MONTGOMERY COUNTY PLANNING DEPARTMENT
THE MARYLAND-NATIONAL CAPITAL PARK AND PLANNING COMMISSION

MEMORANDUM

REVIEW TYPE: Preliminary Plan of Subdivision

PROJECT NAME: Manor Park – Resubdivision of Lot 199

Figure 2: Preliminary Plan

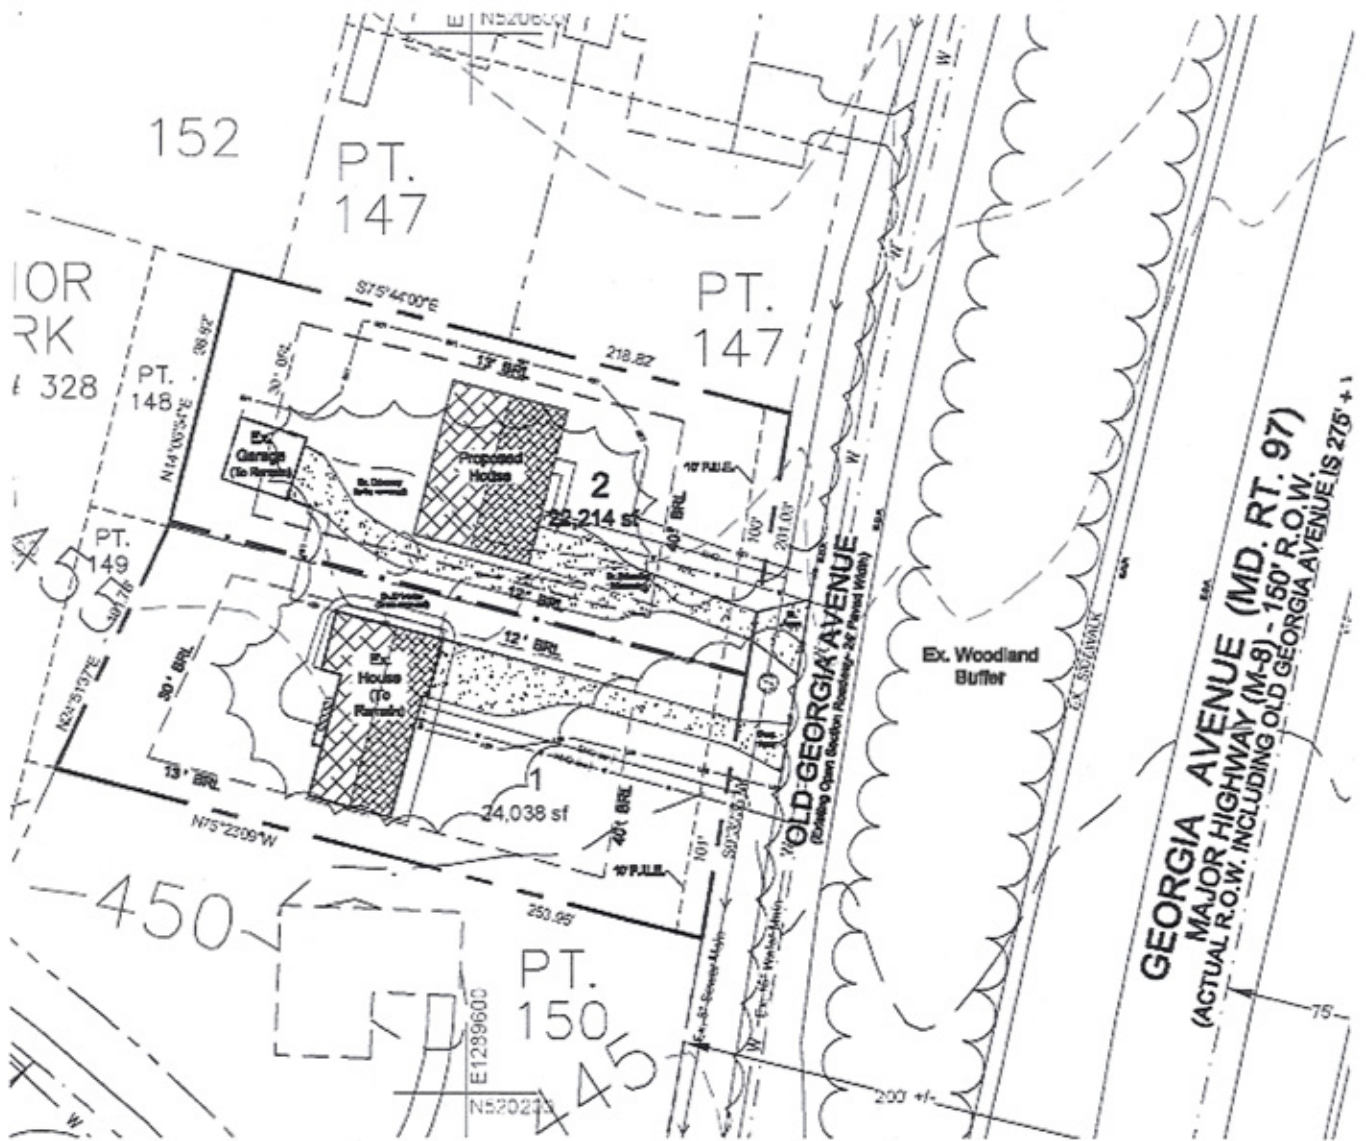
The Applicant proposes to resubdivide the Property and record 2 lots for 2 one-family detached residential dwelling units, as shown in Figure 2 on the following page. The existing dwelling unit is to remain on the southern portion of the Property as proposed lot 1 with a new driveway to serve the lot. Proposed lot 2, on the northern portion of the Property, will accommodate a new one-family detached dwelling unit but utilize the existing driveway and detached garage. The two proposed lots will be served by public water and sewer house connections and a public utility easement has been provided to accommodate any necessary installation of electric utilities. Proposed Lot 1 is 24,038 square feet and proposed Lot 2 is 22,214 square feet in size.
